## EQUUS BEDS GROUNDWATER MANAGEMENT DISTRICT NO. 2

Re: Application No. 45567 – City of Wichita

APPLICATION REVIEW INFORMATION

Figure 7. – Application No. 45567 Lithologic Log for Test Well at Proposed ASR Well Site

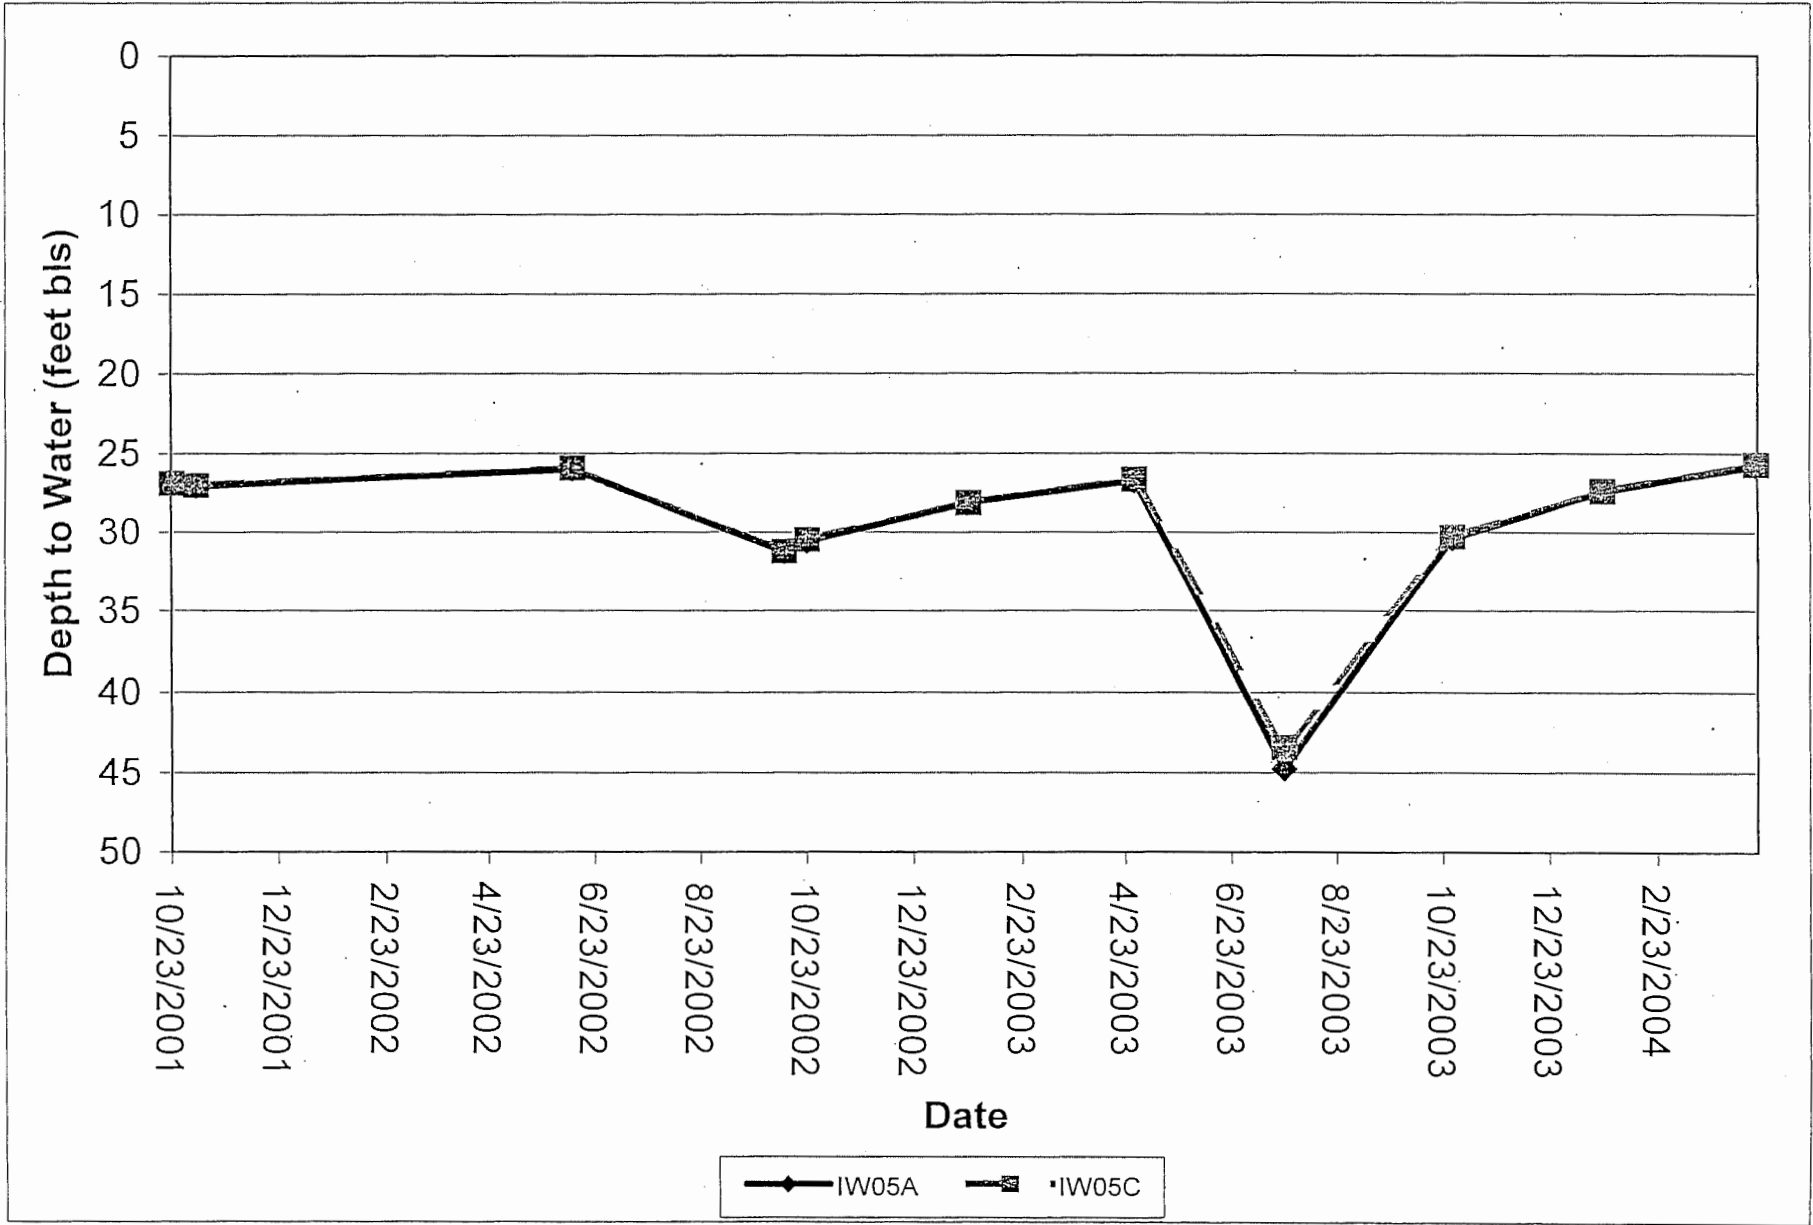
The lithologic log of the proposed well site indicates that the aquifer is comprised of alternating sand and clay layers (figure 7). The clay units range from 2 to 18 feet in thickness. The sand units range from 2 to 35 feet in thickness, with the 35 feet thick unit located from a depth of 116 to 151 feet below land surface.

Figure 9. –  
Application  
No. 45567  
Example of  
Construction  
Design for  
Recharge and  
Recovery Well

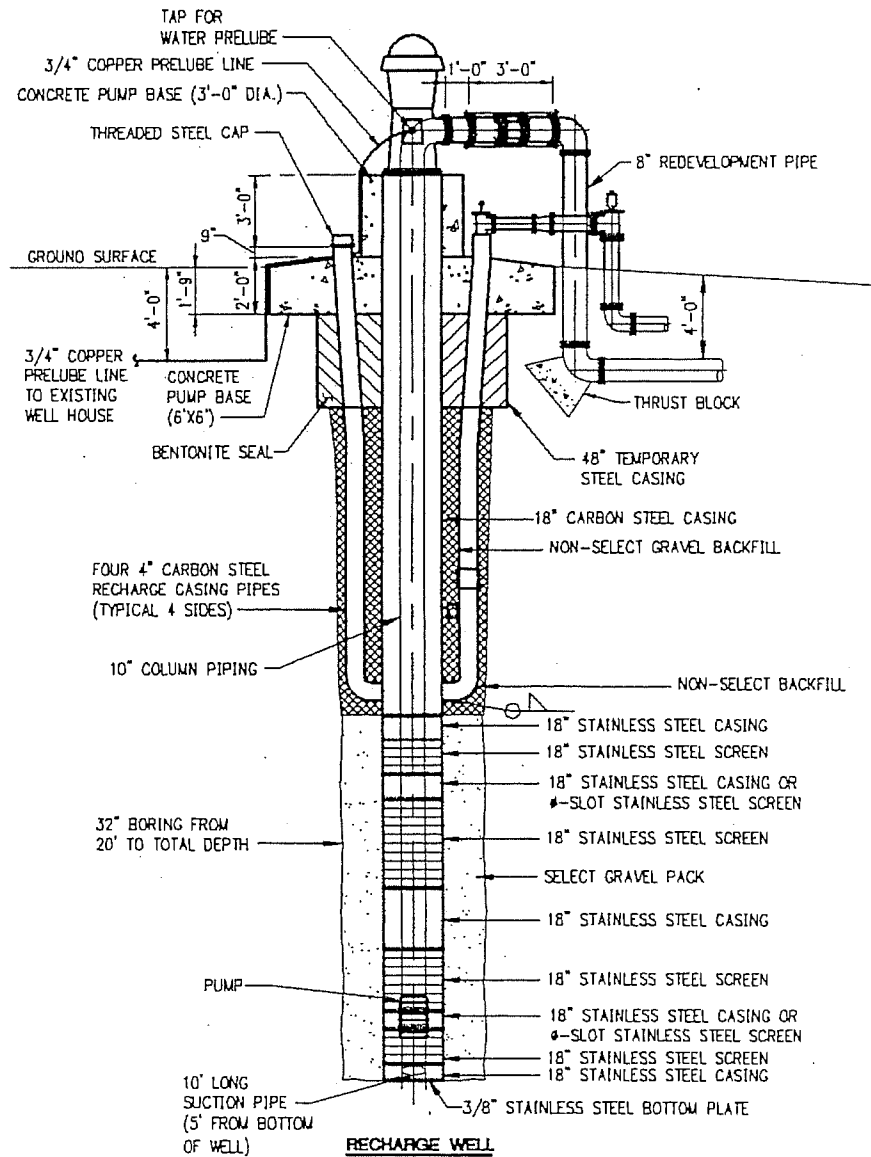
The application's proposed well depth is 189 feet bls to be completed in the lower portion of the aquifer. Proposed well construction specifications were not submitted with the application. An example diagram of recharge and recovery well construction was included in the applicant's demonstration project report (figure 9).

Figure 2. – Application No. 45569 Site Map - SE 08-23S-2W  
 Prepared by: Equus Beds Groundwater Management District No. 2 - 06/30/04

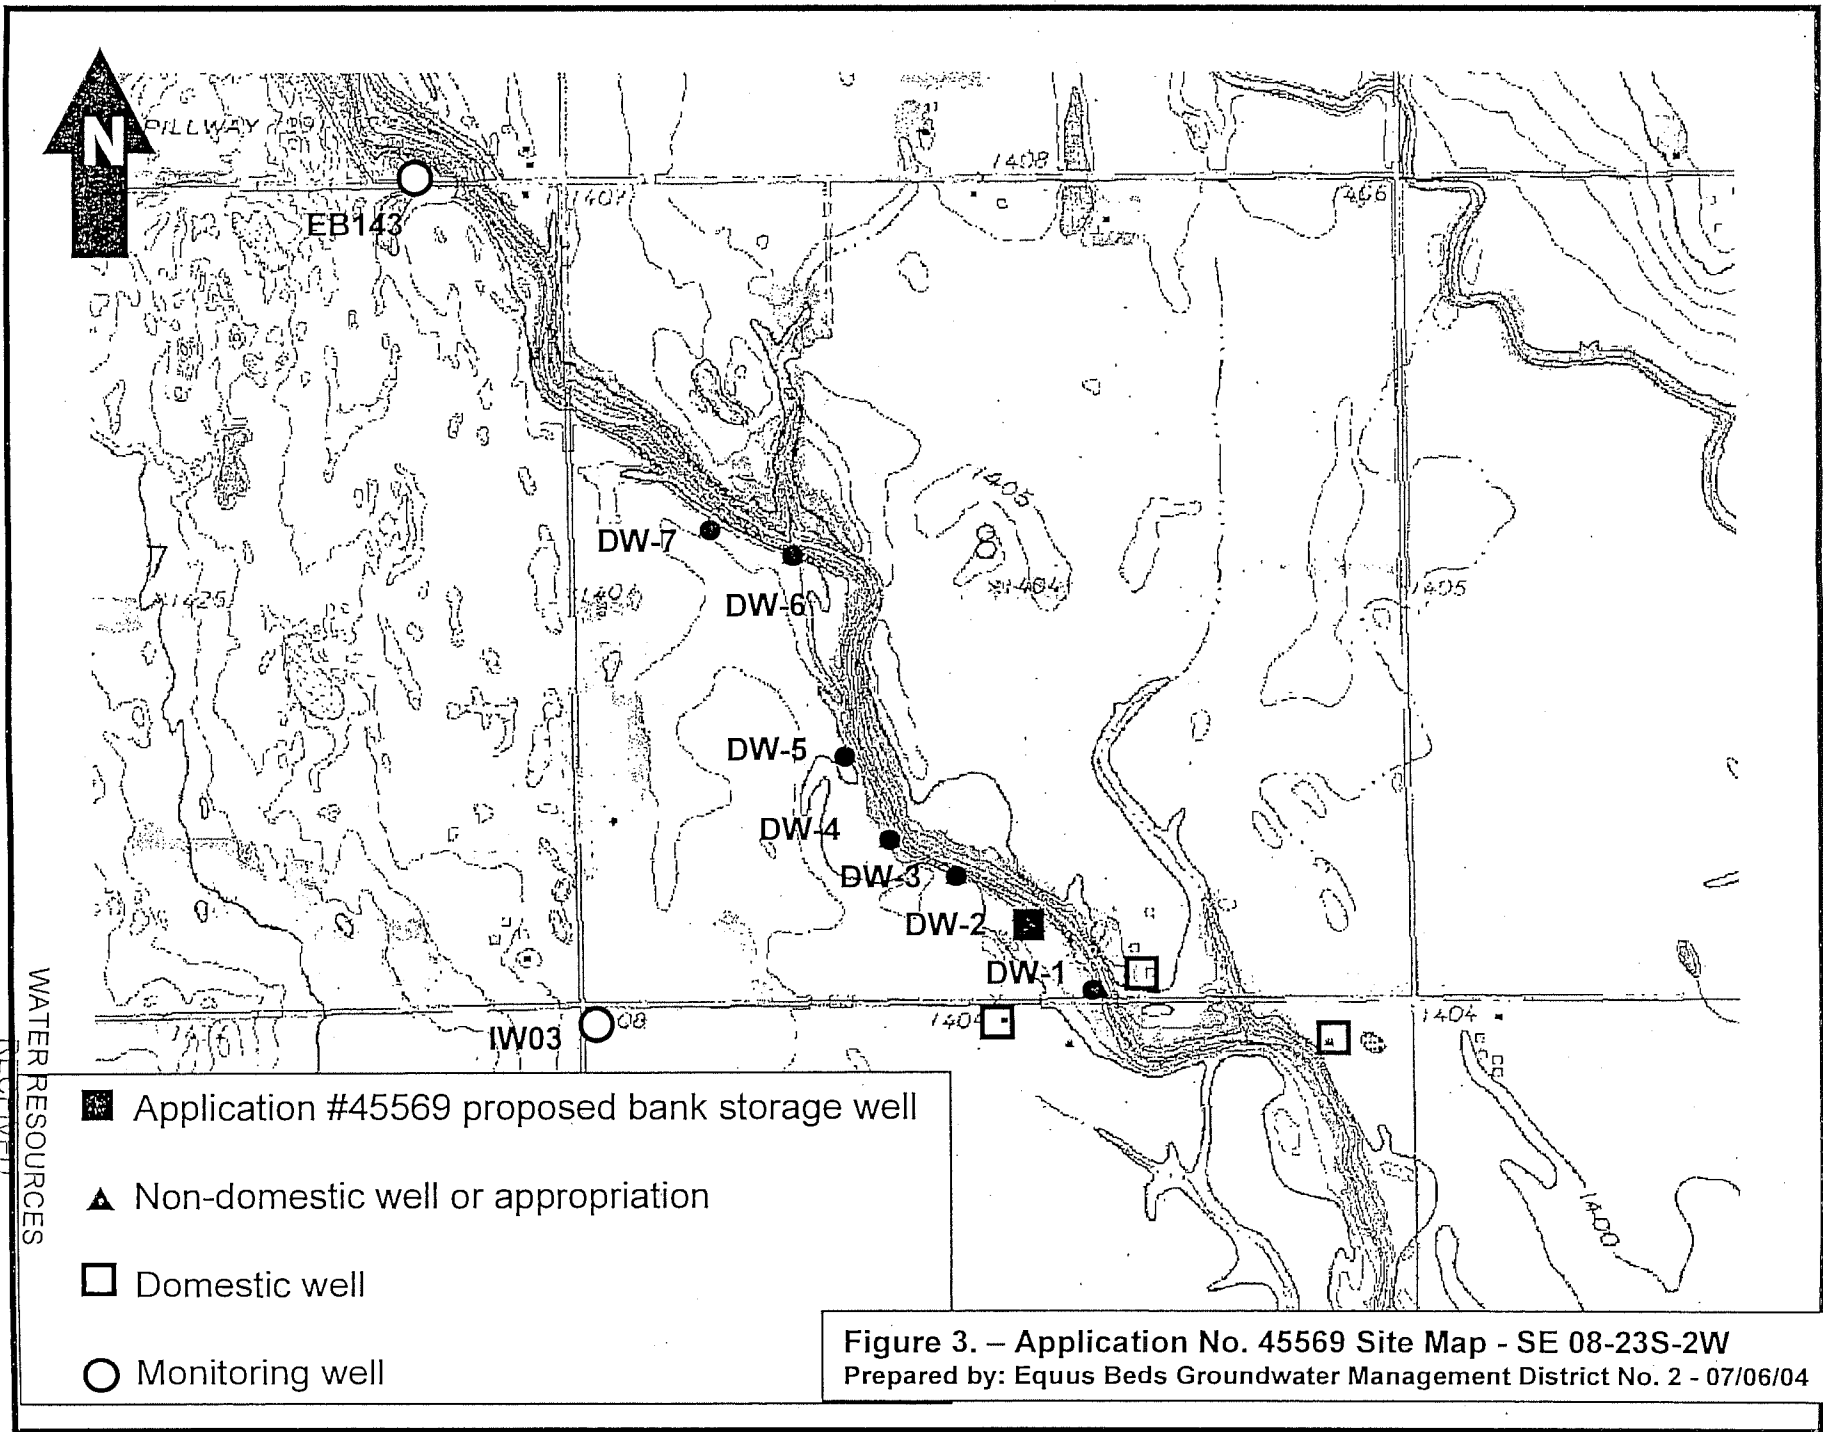
The proposed source water for the applicant's artificial recharge use in the aquifer storage and recovery system, is bank storage water to be diverted from a proposed well located in the SW-SW-SE of Section 8, Township 23 South, Range 2 West (figure 2).

Figure 4. –  
Application  
No. 45569  
Lithologic Log  
and Construction  
Design for  
Bank Storage  
Well

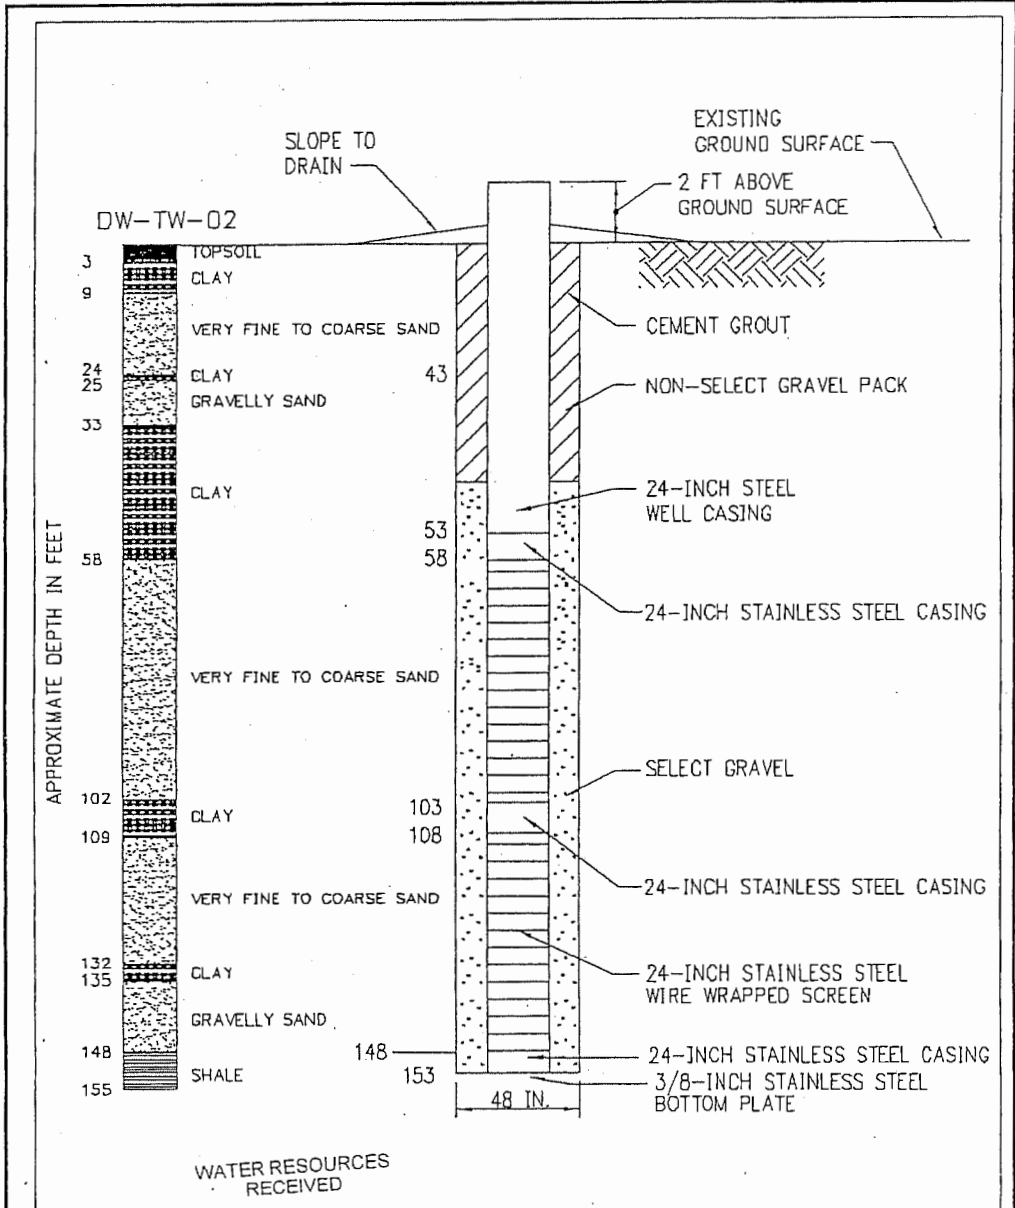
The lithologic log of the proposed well site indicates that the aquifer is comprised of alternating sand and clay layers (figure 4). The proposed well site lithology consists of topsoil 0 to 3 feet bls, clay 3 to 9 feet bls, sand (separated by a thin clay layer) 9 to 33 feet bls, clay 33 to 58 feet

The application's proposed well depth is 148 feet bls (figure 4), with a proposed screen interval from 58 to 148 feet bls. The well is proposed to be screened in the lower portion of the aquifer below the clay unit located from 33 to 58 feet bls. The applicant proposes to utilize a 24-inch diameter well casing and screen.

Figure 5.

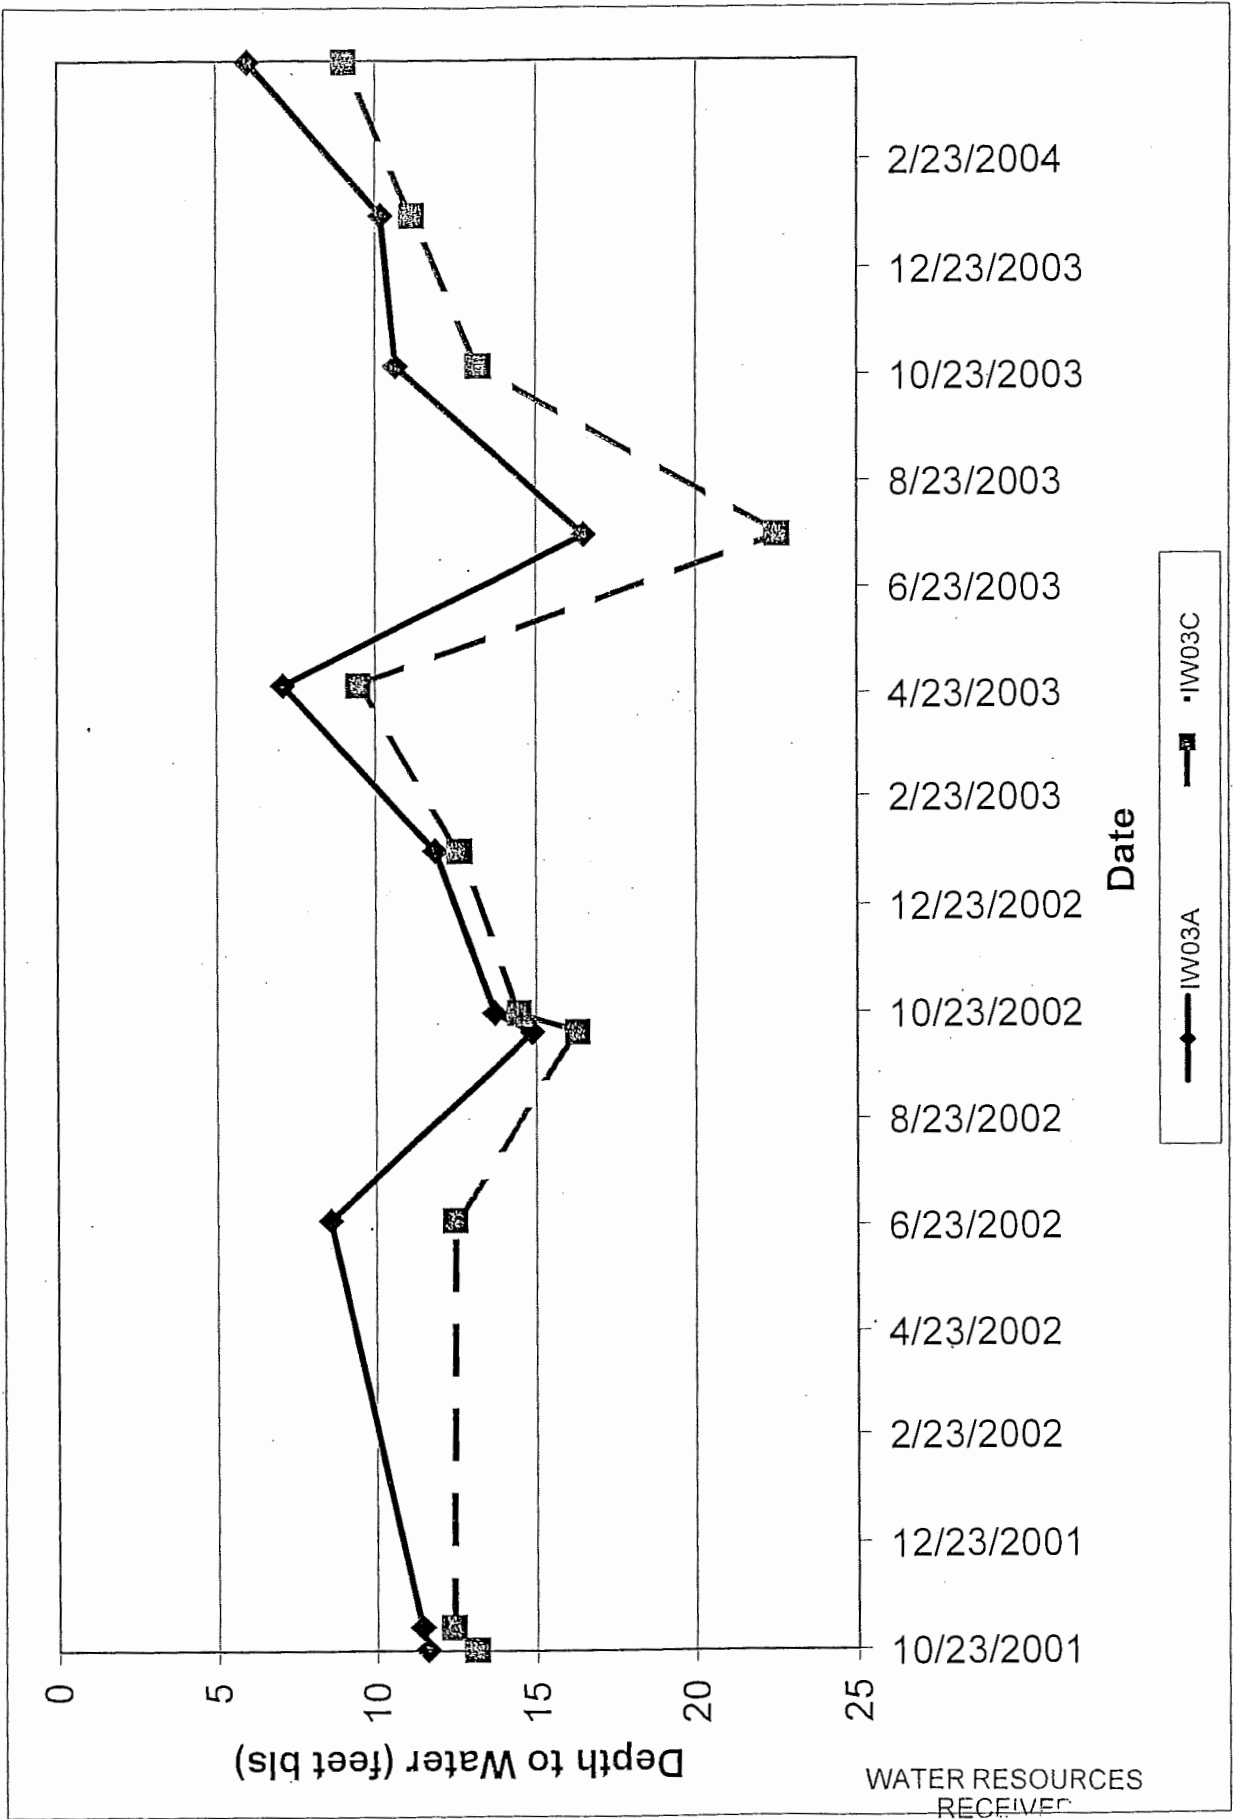
IW03 water level data (figure 5) indicated that a head difference ranging from approximately 1 to 6 feet existed between the upper zone (A well) and the lower zone (C well). The water levels in both zones exhibited similar responses to water table fluctuations, indicating a hydraulic connection. The fluctuation responses indicated leakage occurrence from the upper zone to the lower zone. Pumping effects exhibited in the lower zone also affected water levels in the upper zone. The correlation between the data sets indicated that the clay unit separating the two zones is not continuous throughout the area.
